ARM Group Inc. Engineers and Scientists

> Re: Response and Development Work Plan Addendum Area A: Sub-Parcel A8-1 Tradepoint Atlantic Sparrows Point, MD 21219

FINAL GRADING PLAN

GOTHAM GREENS

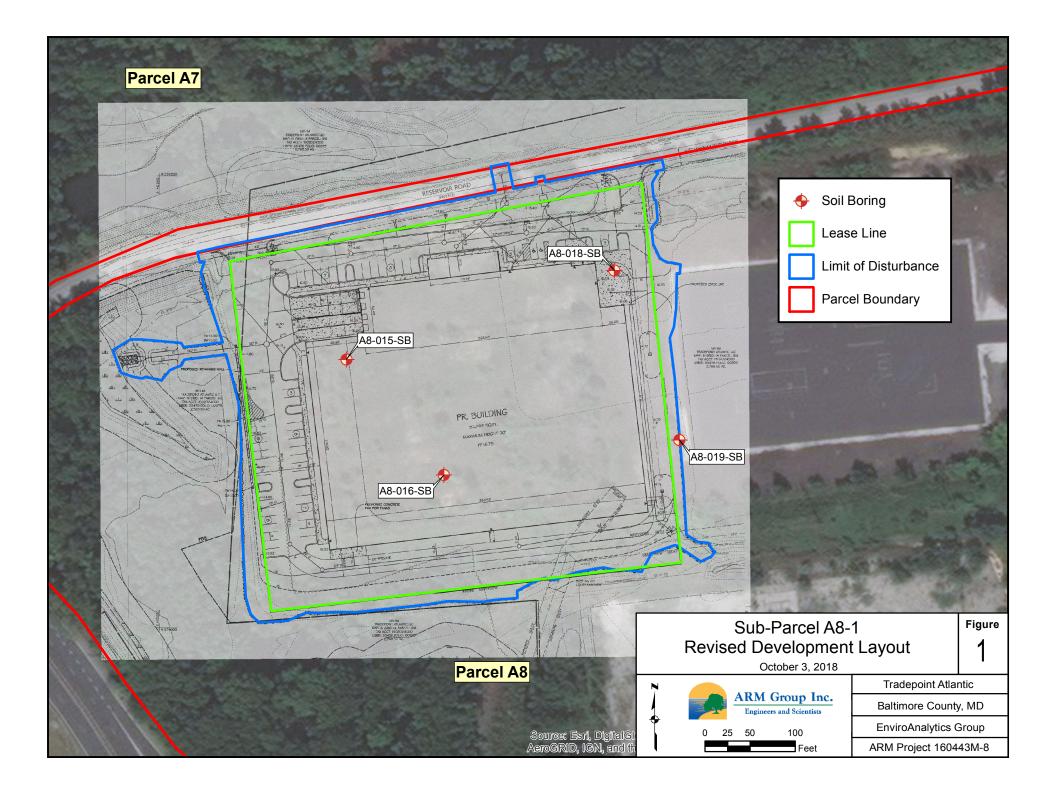
The Site is currently slated for development with a new industrial structure, access drives, parking areas, and a stormwater outfall to the west (**Figure 1**). Tradepoint Atlantic provided ARM with an updated development plan via email on September 21, 2018 that shows an increase in the area of the lease line from approximately 4.1 acres to 4.3 acres. The revised plan also shows the anticipated limit of disturbance (LOD), encompassing the main development area as well as the western stormwater outfall, with a total area of 5.0 acres. Since the changes in the size of the development area were nominal and no additional data from Phase II Investigation soil borings are either included or excluded from the development boundary, the procedures and conclusions of the SLRA remain valid.

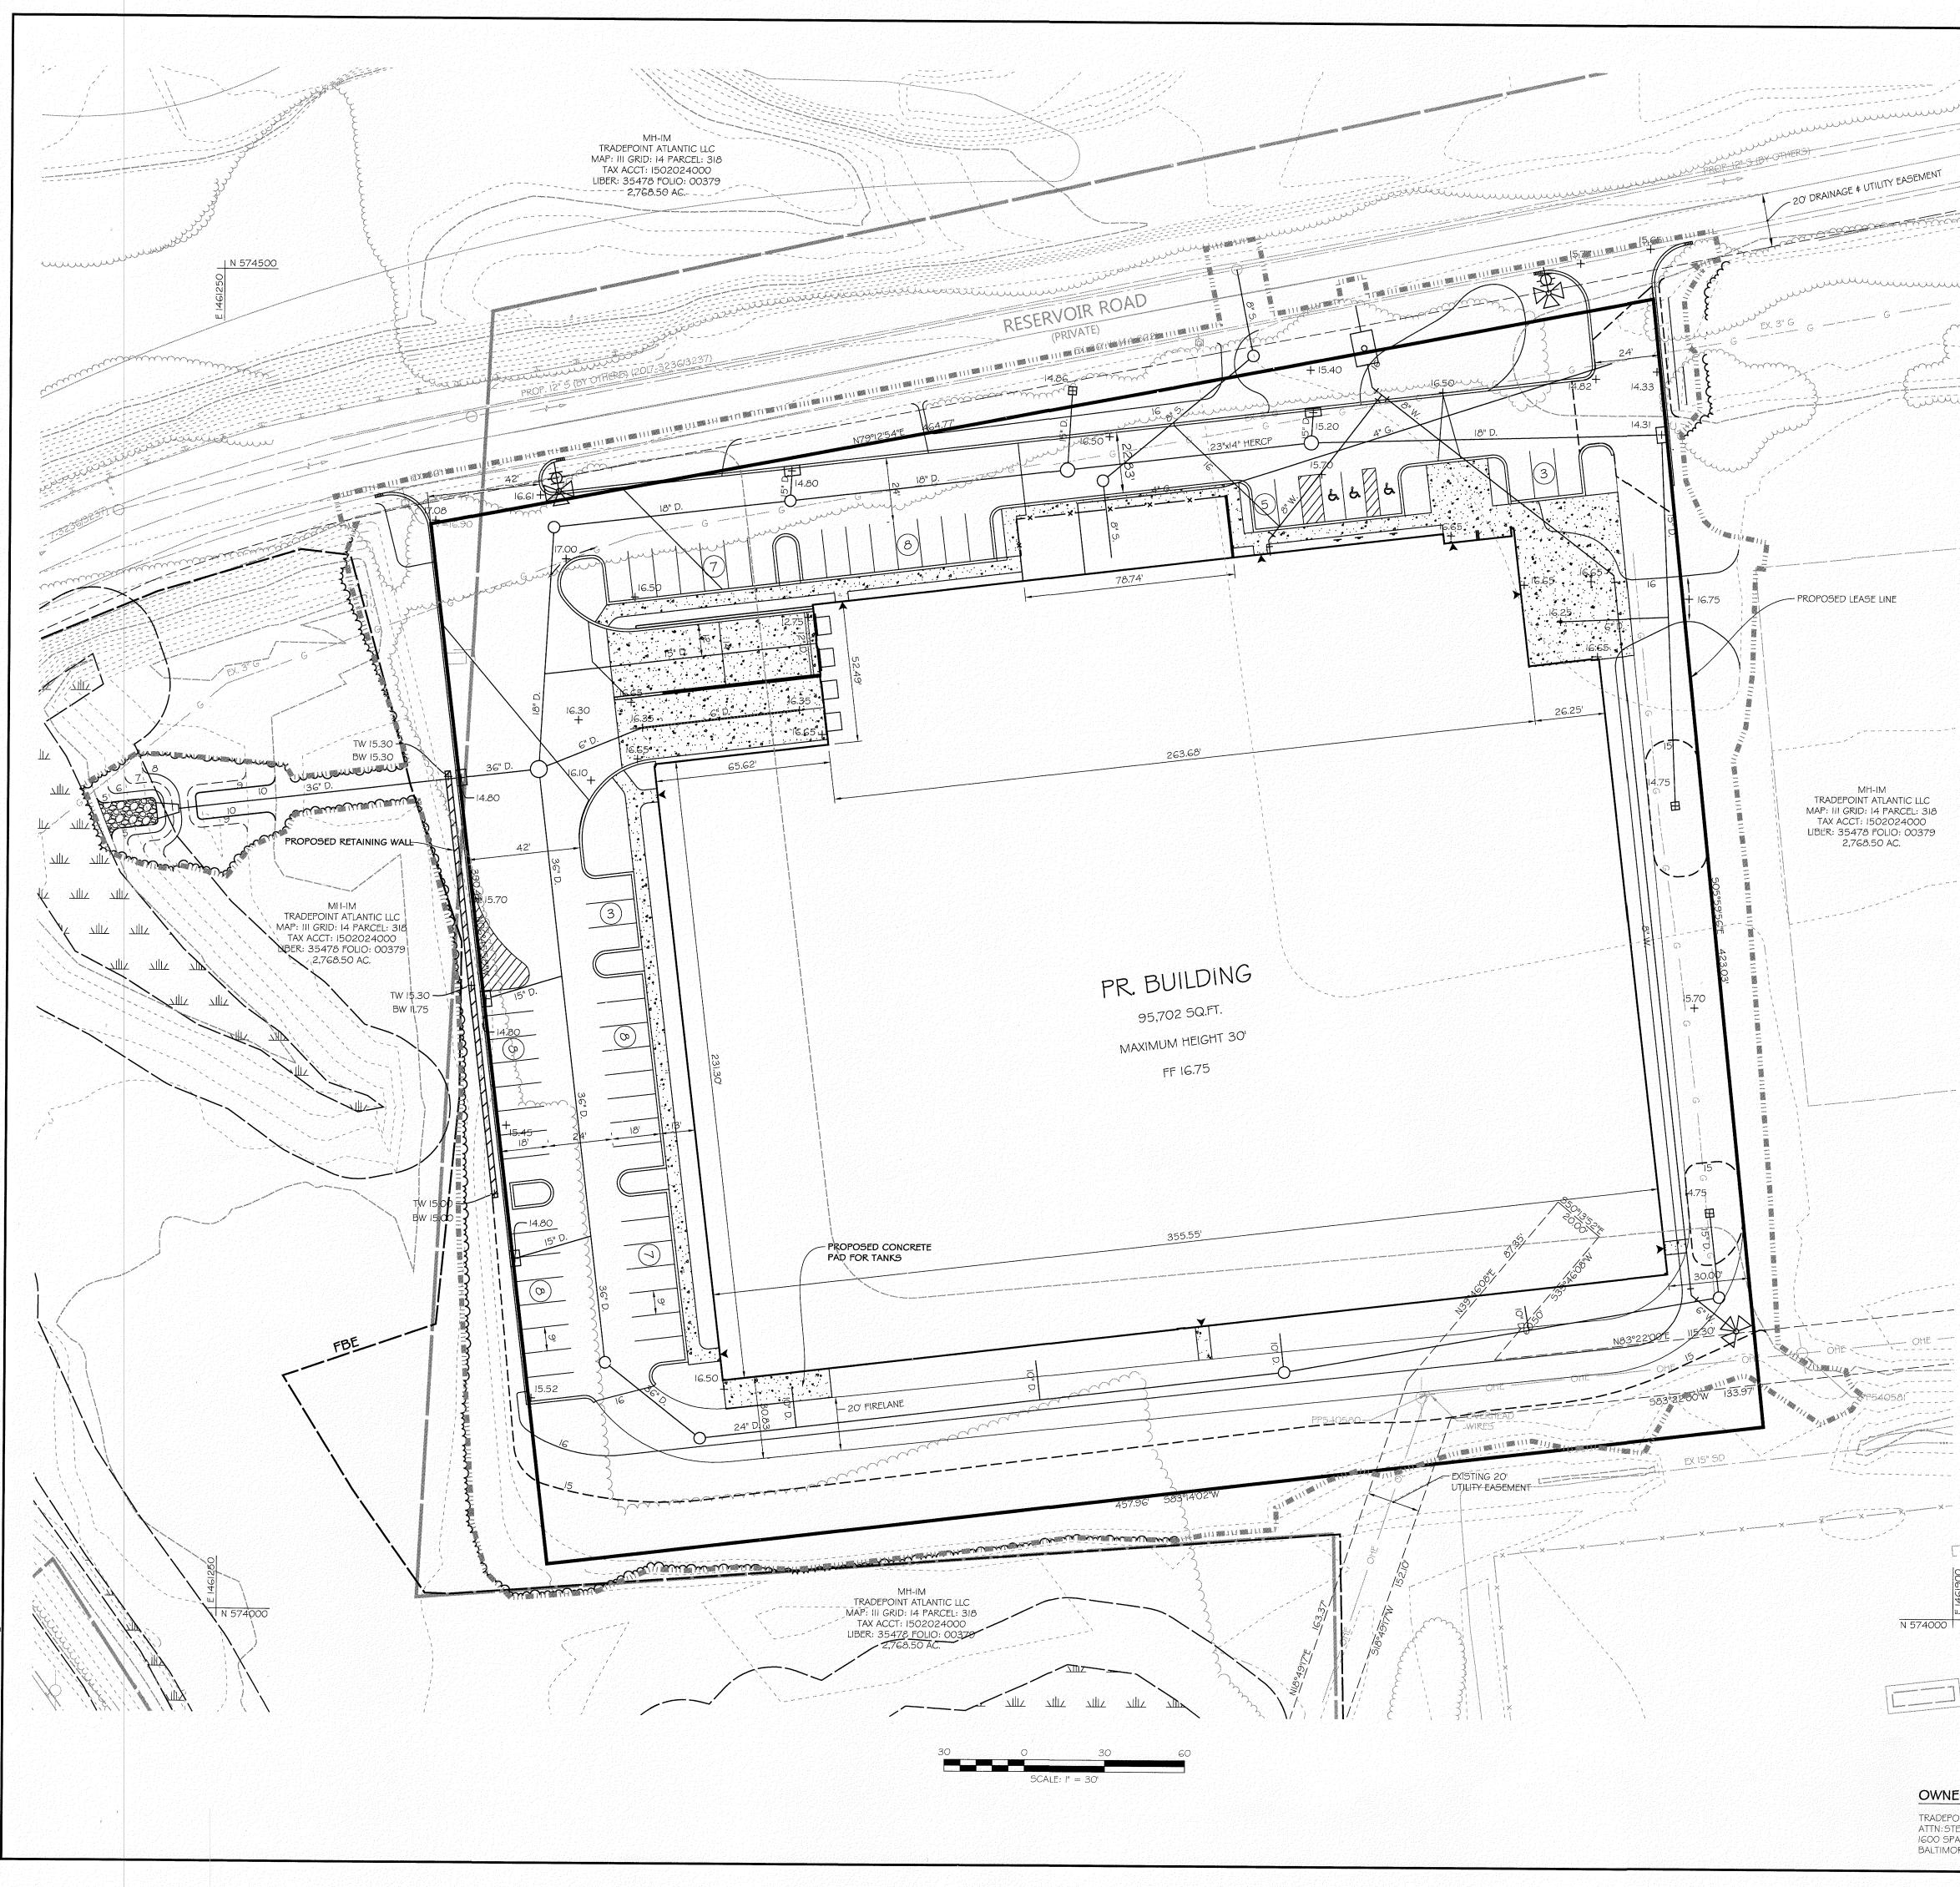
The new industrial structure will be constructed with an area of approximately 95,000 square feet. According to the development plans, the finished floor elevation for the structure has been revised from the original proposed elevation of 14.50 feet above mean sea level (amsl) up to a new proposed elevation of 16.75 feet amsl. Tradepoint Atlantic has proposed to use soil as fill material for the increased floor elevation. At this time, processed slag aggregate sourced from

The updated development drawings for Sub-Parcel A8-1 are provided with this RADWP Addendum as **Attachment 1**. As stated above, the revised development plan does not necessitate any significant adjustments to the SLRA, nor were any revisions required in the text of the approved RADWP (Revision 0). Although the area of the LOD increased slightly according to the revised development plans, the conclusions of the SLRA were not affected. The development implementation protocols and oversight requirements, etc. will remain the same as in the approved version of the RADWP.

the Tradepoint Atlantic property is not proposed to be used as fill material. The selected soil will be tested, and the results will be provided to the MDE to determine if the proposed material meets the MDE's requirements for industrial clean fill and whether a cap is needed.
